1. Response to Reasons for Refusal – Traffic and Transport

Following submission of the Development Application (DA-1182/2024) for the redevelopment of the Altis Compass Centre in Bankstown, Canterbury Bankstown City Council (CBCC) have recommended refusal of the application.

PROJECT
BANKSTOWN COMPASS
CENTRE

CLIENT	BARINGS
DRAWING #	PTC - 001a
PROJECT #	23-0601
SCALE	1 : 150 @ A3

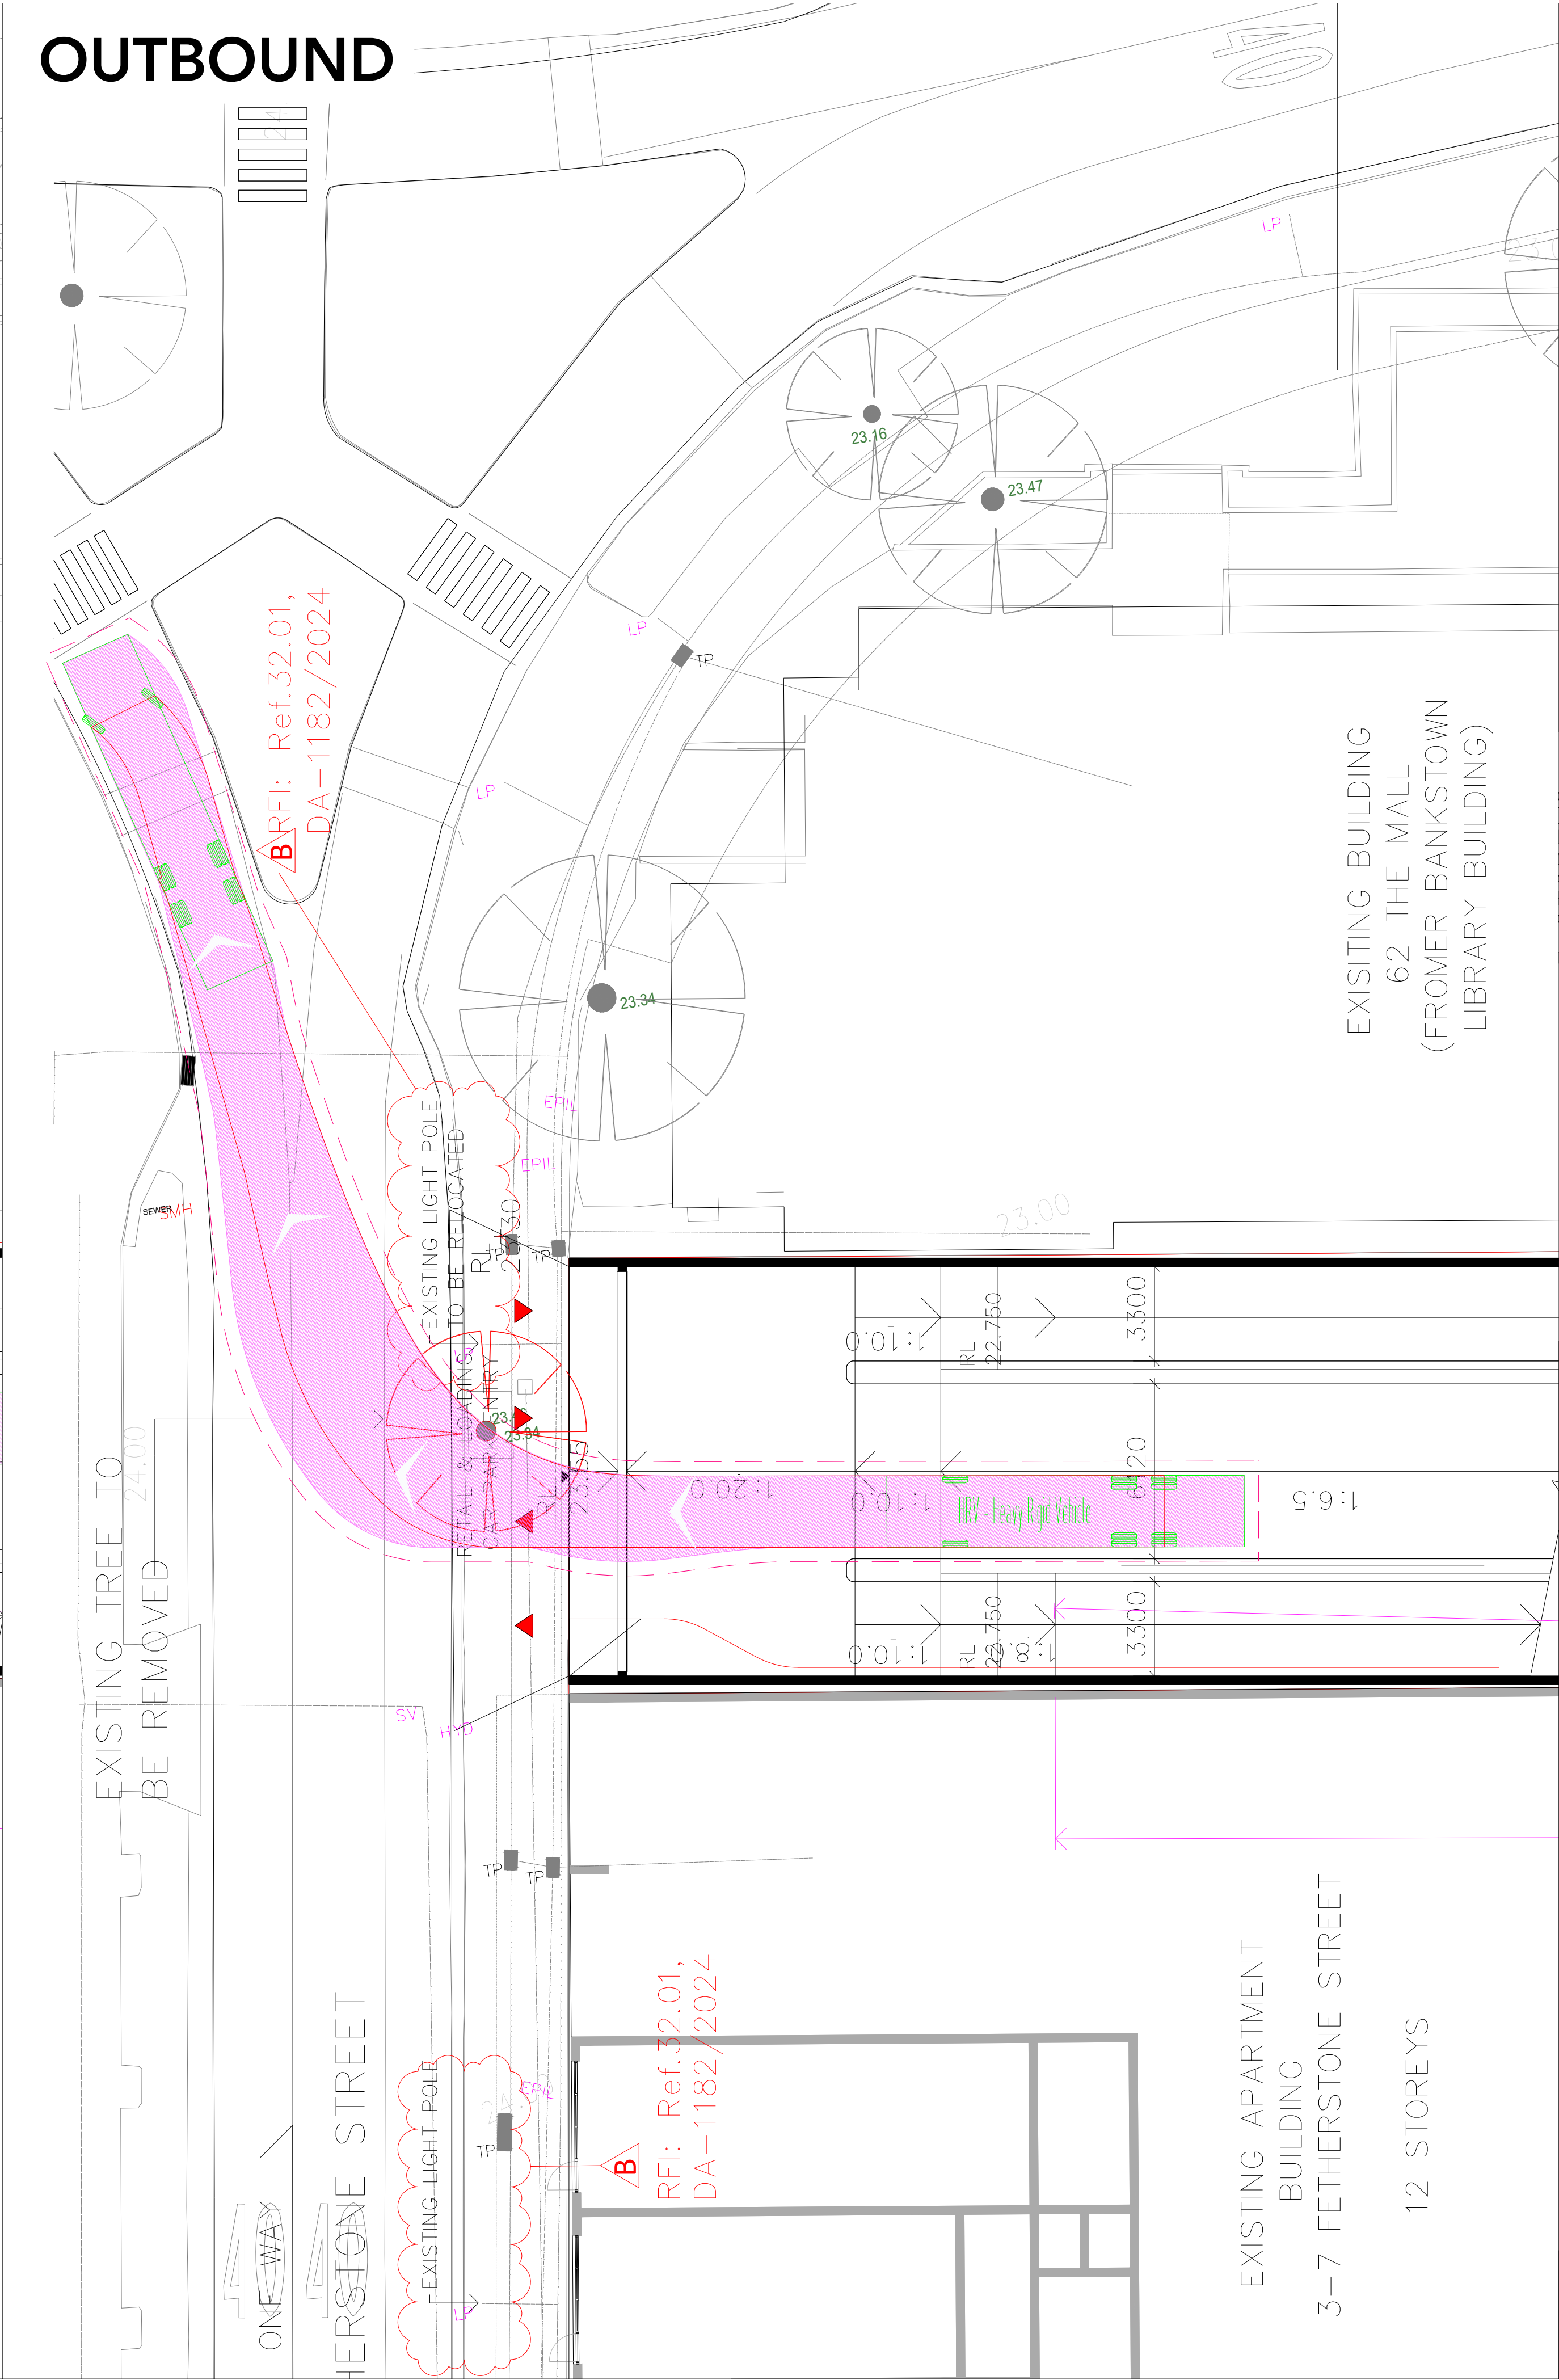
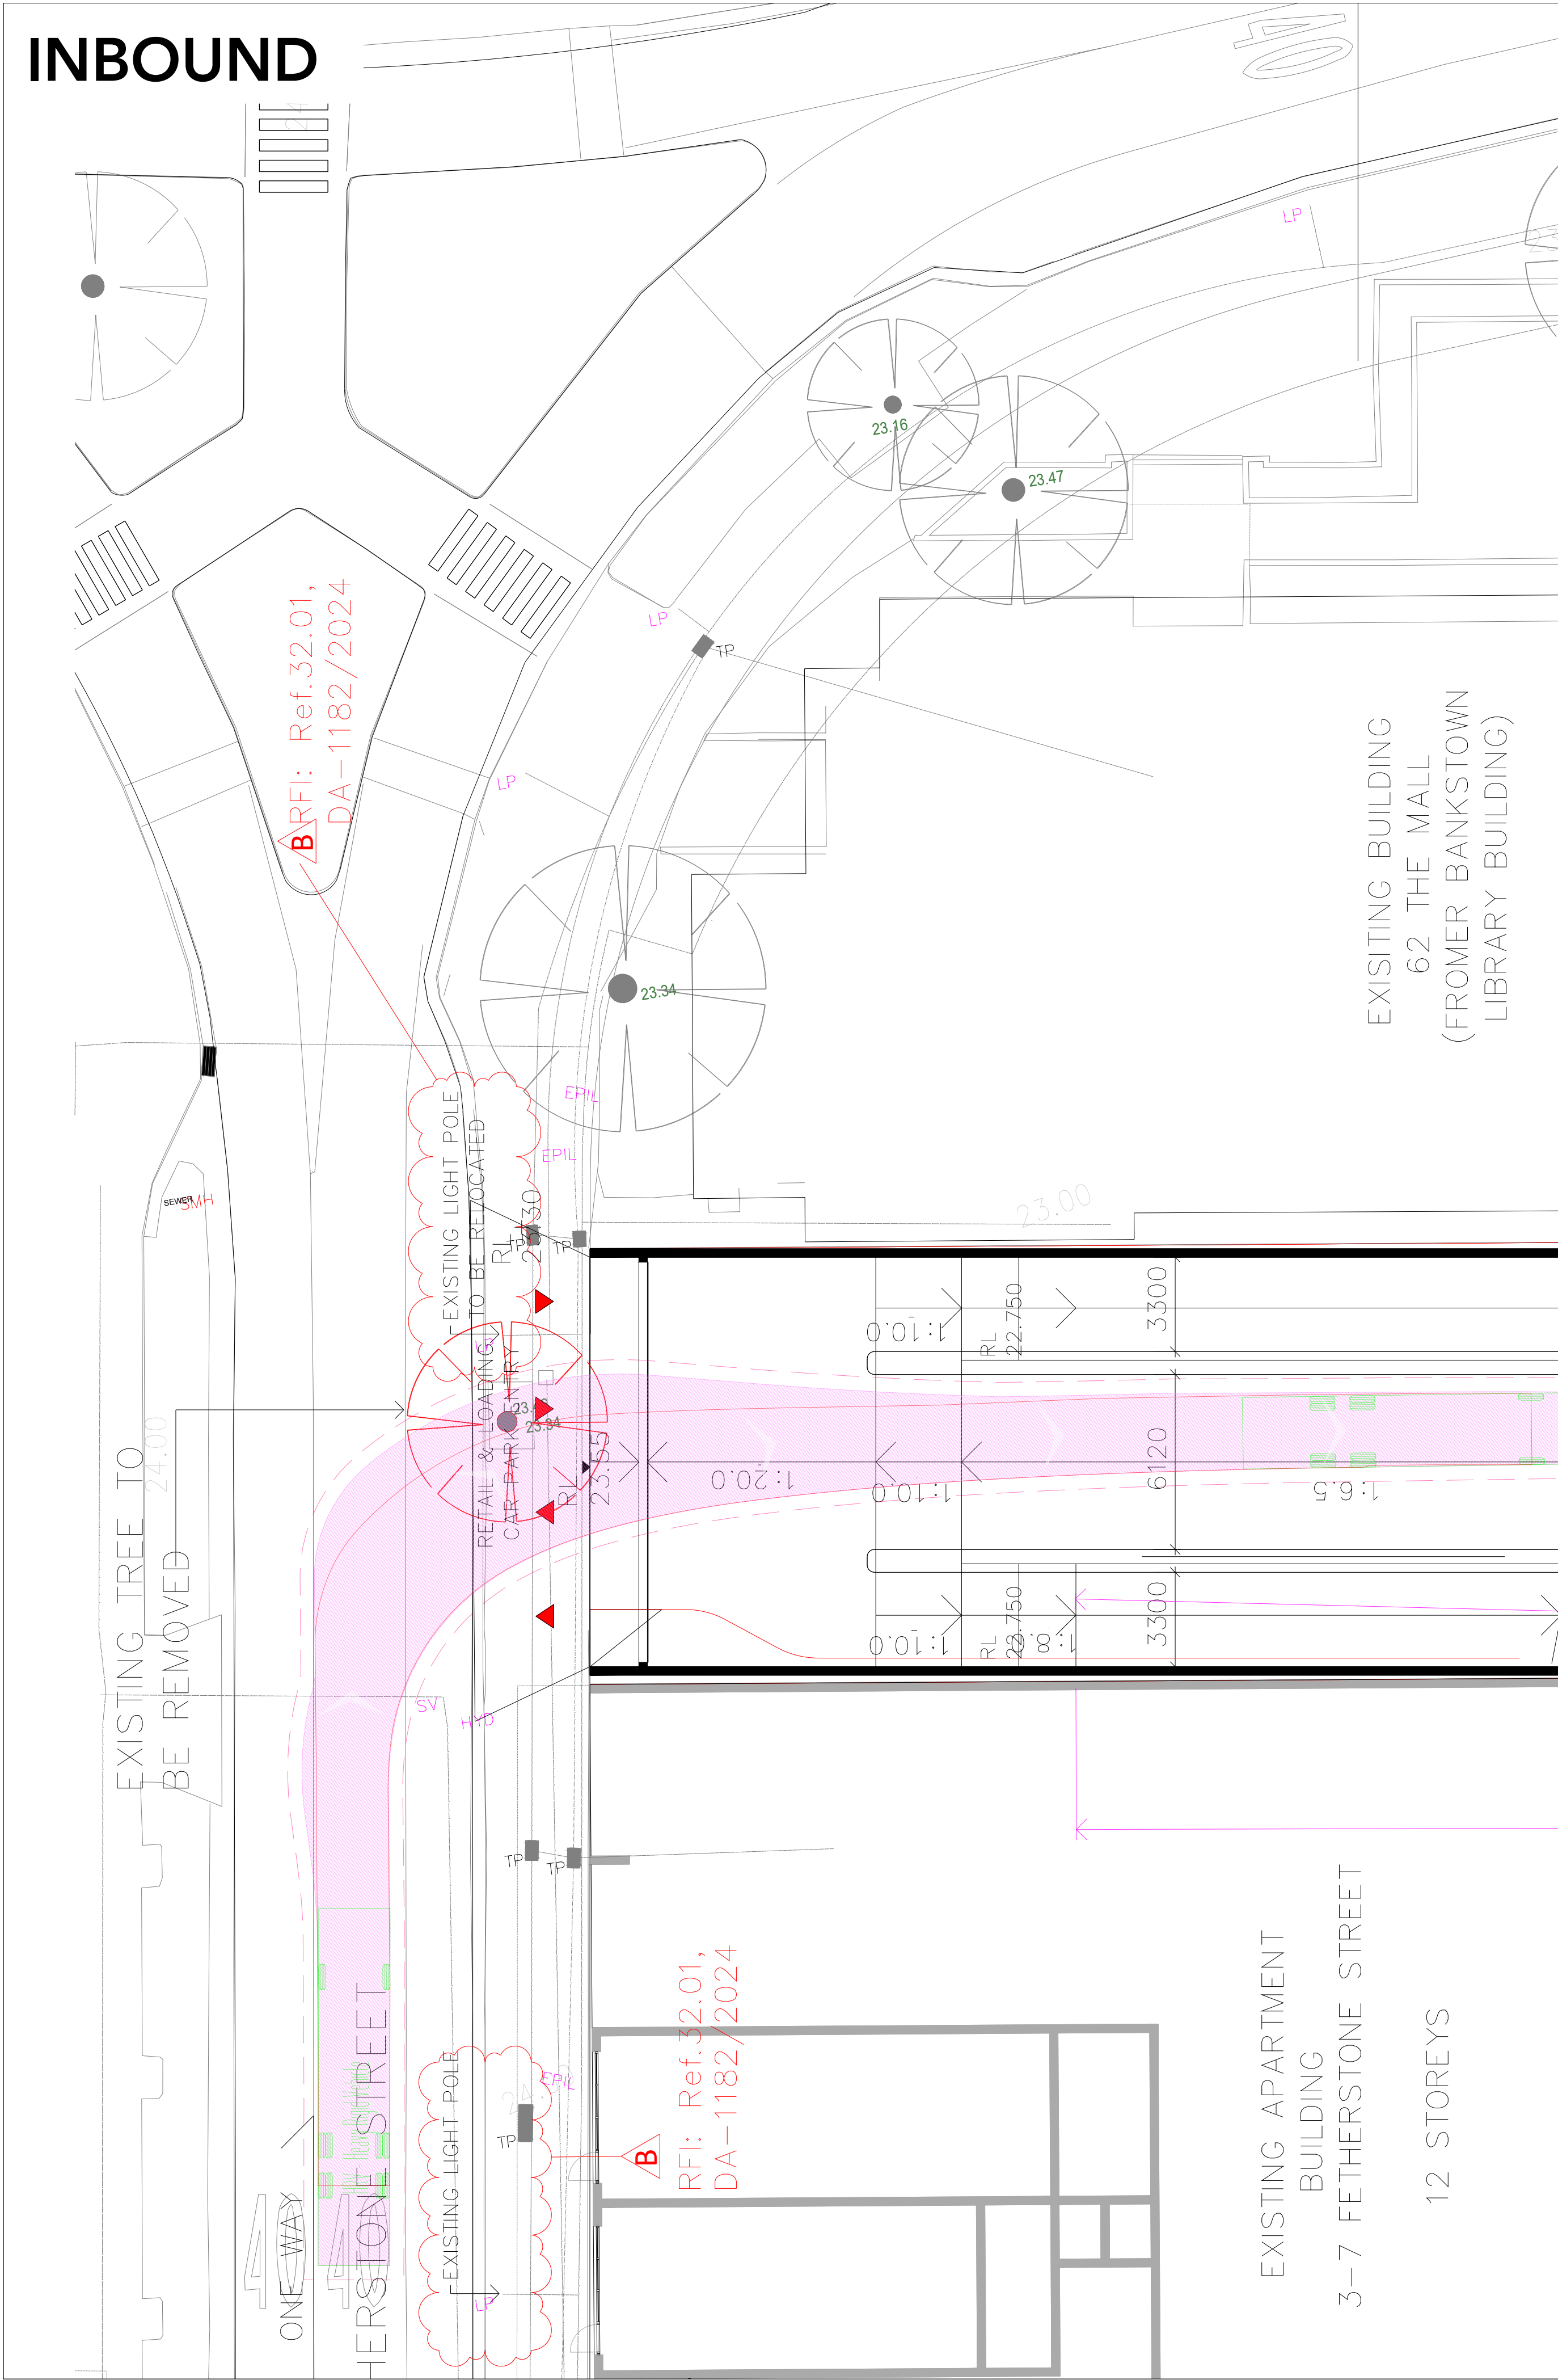
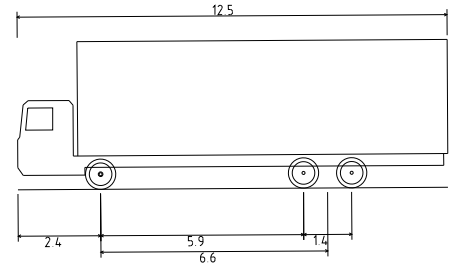
The direction of the swept paths do not reflect the current direction of traffic which is one way northbound.

Swept path analysis has been provided within the submitted Traffic Impact Assessment (TIA) that demonstrated vehicles entering and exiting from the north as per the Complete Streets configuration, noting that Fetherstone Street is currently one-way northbound. For completeness, swept path analysis for the largest vehicle requiring access to the site (HRV – Council Waste Collection) for both the existing (dwg PTC-001a) and future Complete Streets configuration (dwg PTC-001) of Fetherstone Street is contained as Annex A.

The swept path analysis has been completed based on the future scenario whereby cars and trucks would enter and exit the site from the North. Annex A presents both scenarios for ease.
